Ballinlea E/2013/0093/F – Construction of an exploratory borehole to a depth of approximately 2700m including conventional exploratory testing to evaluate the potential hydrocarbon reserve in the Rathlin Basin under DETI license pl 3/10 issued to Rathlin Energy Ltd. Site preparation comprising ground works and ancillary operations to include: road widening of part of the Kilmahamogue Road, parking, offices and workshops, earth bunding, flood lighting, wheelwash, storage area, security fence and site restoration on lands at 49 Ballinlea Road, Ballycastle for Rathlin Energy Ltd.

Review of Hydrological & Hydrogeological ES Information

From: Conor Lydon, WYG Principal Hydrogeologist, 27th March 2015

Planning Application Reference: E/2013/0093/F

2.5.4 Drilling Muds and Water - The ES states that the following water volumes will be required during the drilling process:

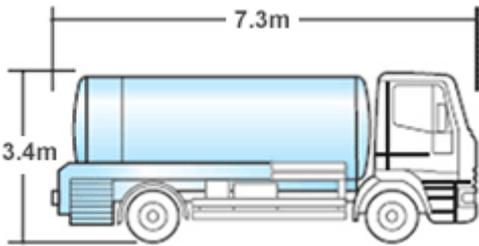
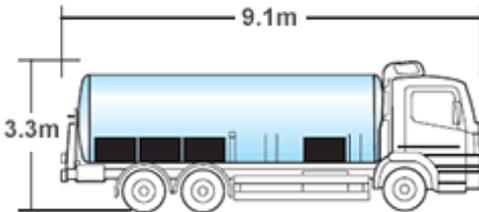
Despite the conflicting information in terms of the drilling works duration we have completed some preliminary calculations based on a drilling duration (phase requiring water; excluding testing, mobilisation and demobilisation) of between 7 and 12 weeks.

Based on the anticipated water requirements detailed in Section 2.5.4 it is likely that between 520,000m³ (7 weeks) - 872,000m³ (12 weeks) will be required to facilitate the drilling of Ballinlea 2. The Department of Transport (UK) defines Heavy goods vehicles (HGV) as all goods vehicles over 3.5 tonnes gross vehicle weight. A standard HGV water tanker typically carries 30m³ of water. The inset below provides an overview of typical water tanker specifications, namely capacity, discharge capability and turning circle.

We request that DOE Planning seek clarification on what the source of water will be and that a full evaluation of all risks associated with the sourcing of water be completed. Without this information risks associated with the application cannot be fully assessed. We request that clarification is sought in terms of the expected total volume of water required during the project and that the Applicant consider what direct and indirect implications this has on noise, dust, water resources, traffic and public health as a minimum.
